MONITORING REPORT
2020 (Year 2)

MAJOR HILL STREAM AND WETLAND MITIGATION SITE
Alamance County, North Carolina

DMS Project ID No. 100015
Full Delivery Contract No. 7193
USACE Action ID No. SAW-2017-01472
DWR No. 17-0921
RFP No. 16-006990

NCDMS comment responses:

Figure A. Riparian Buffer Asset Map
Figure B. Riparian Buffer Planting Map

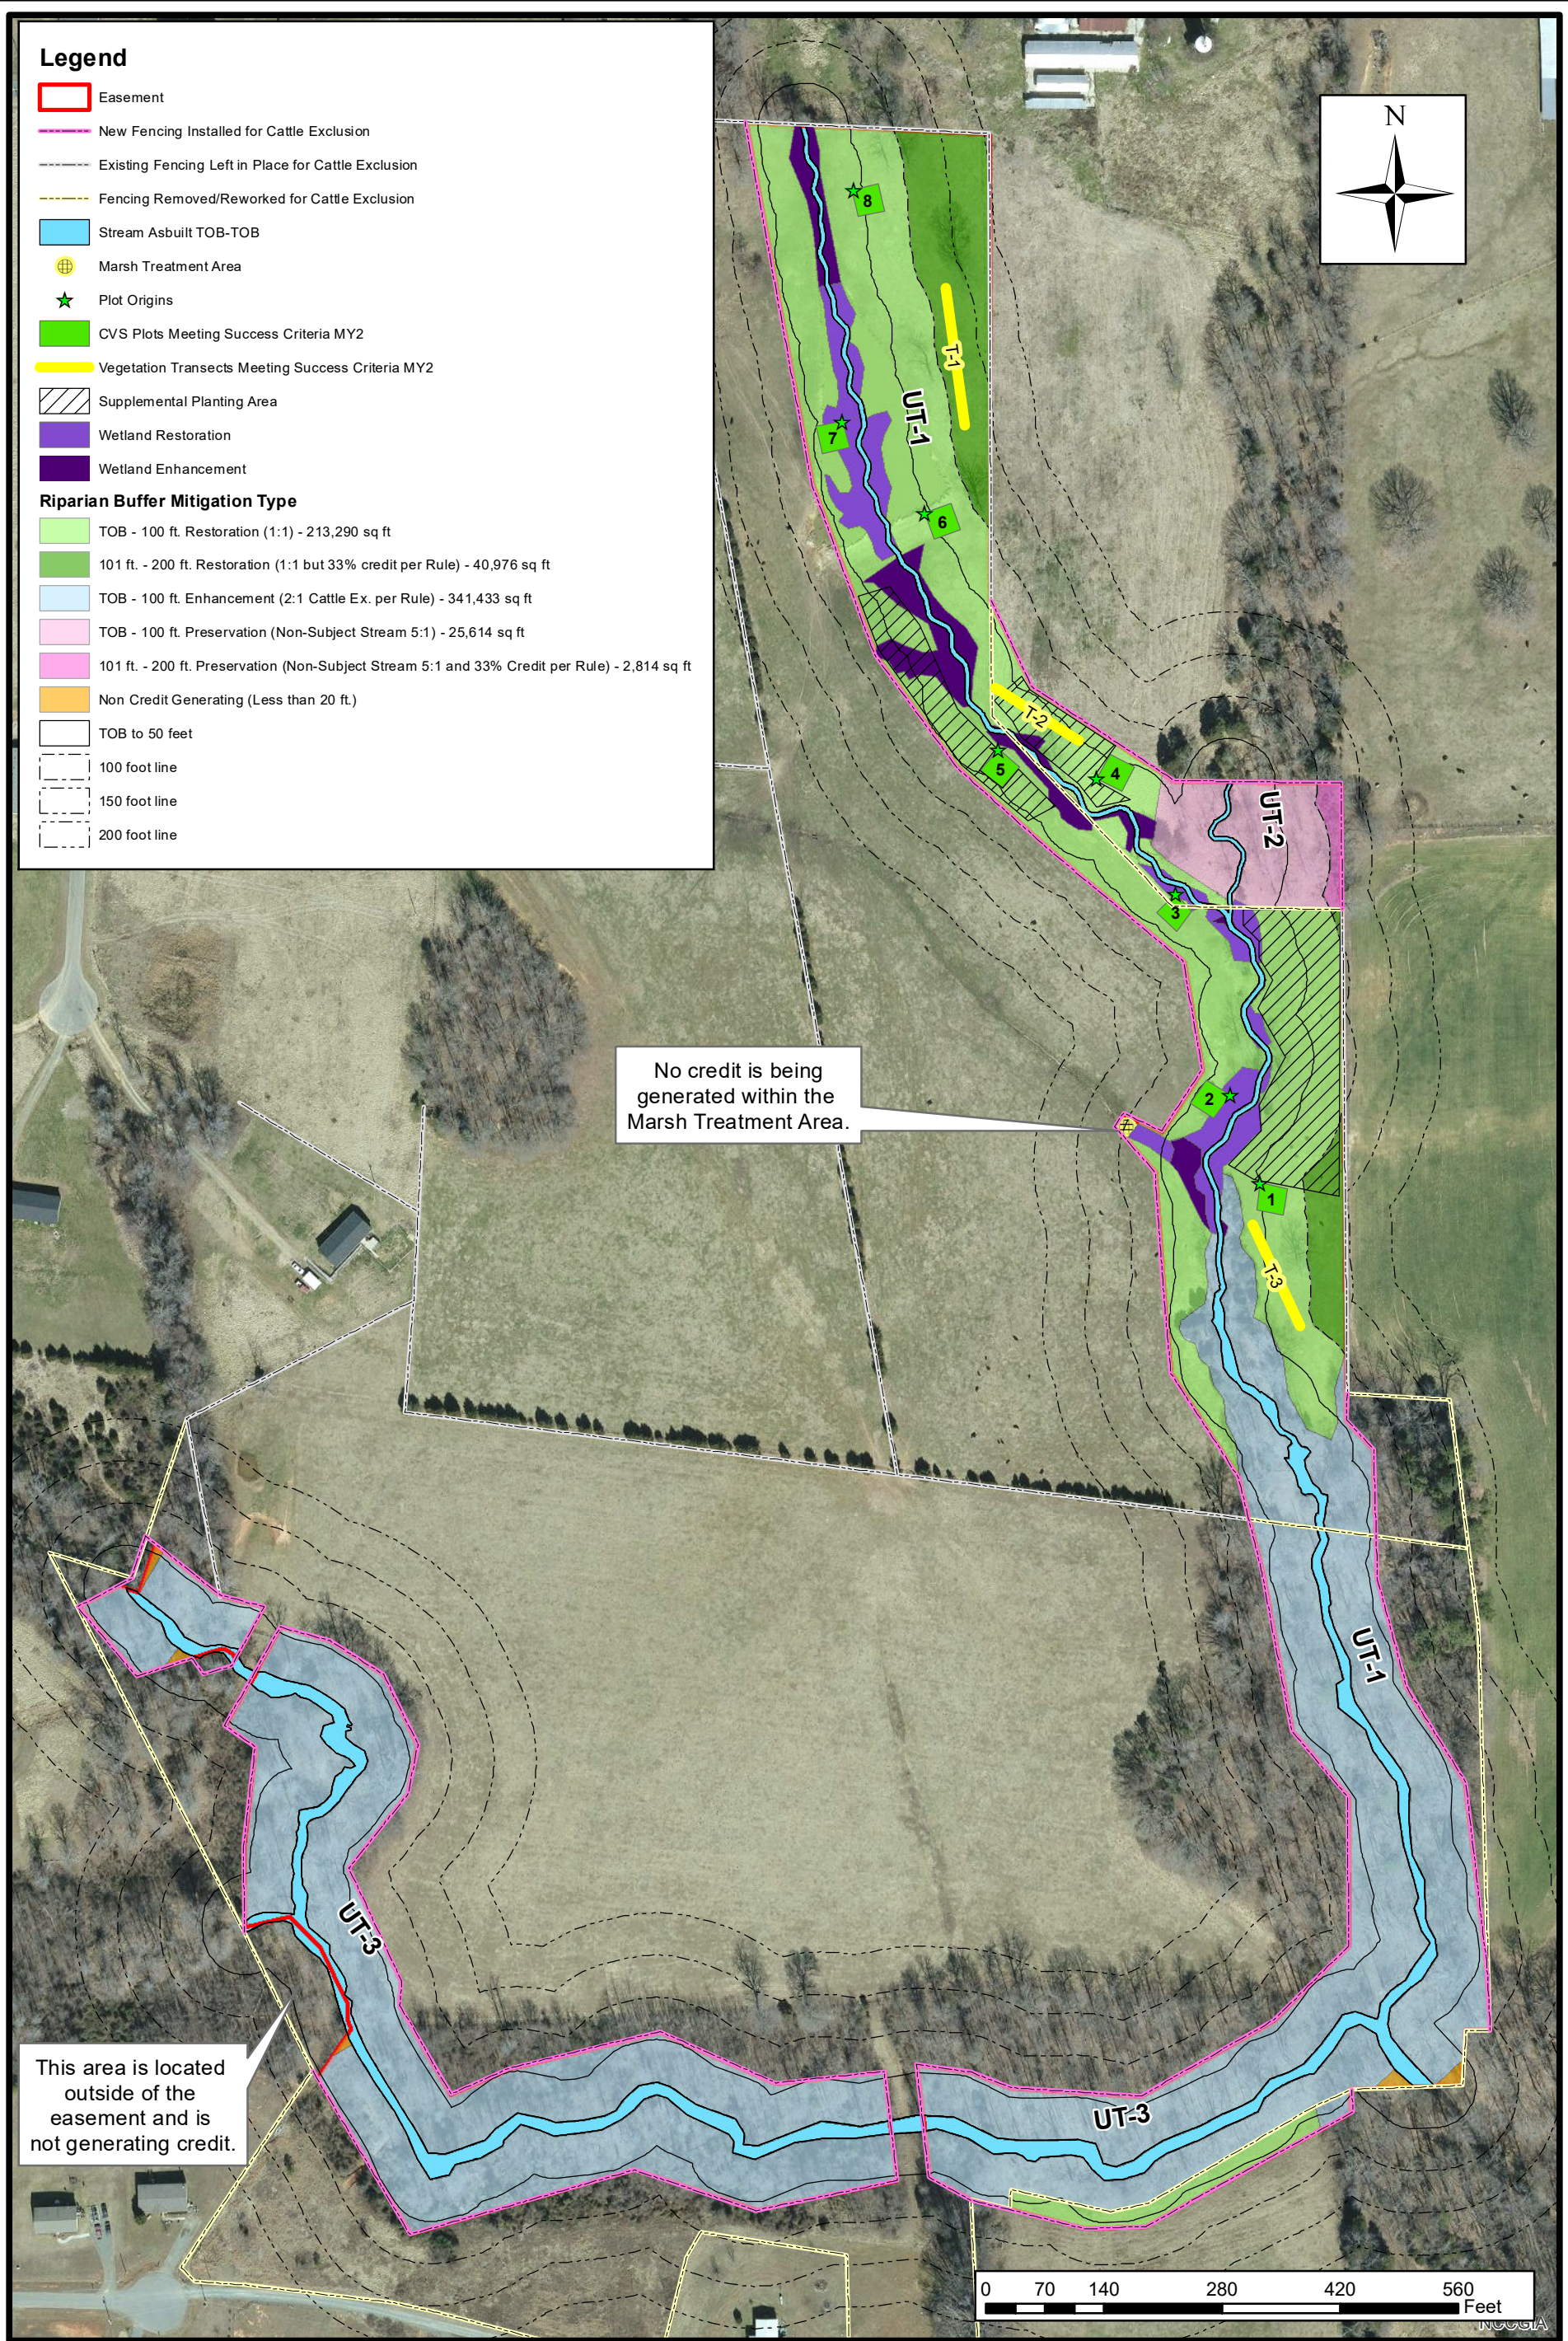
1. Section 4.3, Table 5, Table 6, and Figure A state that 2 vegetation plots did not meet success. Riparian buffer success is based on 260 stems/acre planted AND volunteer at MY5. Please revise these report items to reflect this.
The riparian buffer section was revised to indicate that all vegetation plots are meeting the success criteria of 260 stems/acre.
2. Add discussion of replanted area to Riparian Buffer report and to Figure A.
A discussion of the replanted area was added to section 4.3 of the Riparian Buffer report, and the polygons were added to Figure A.
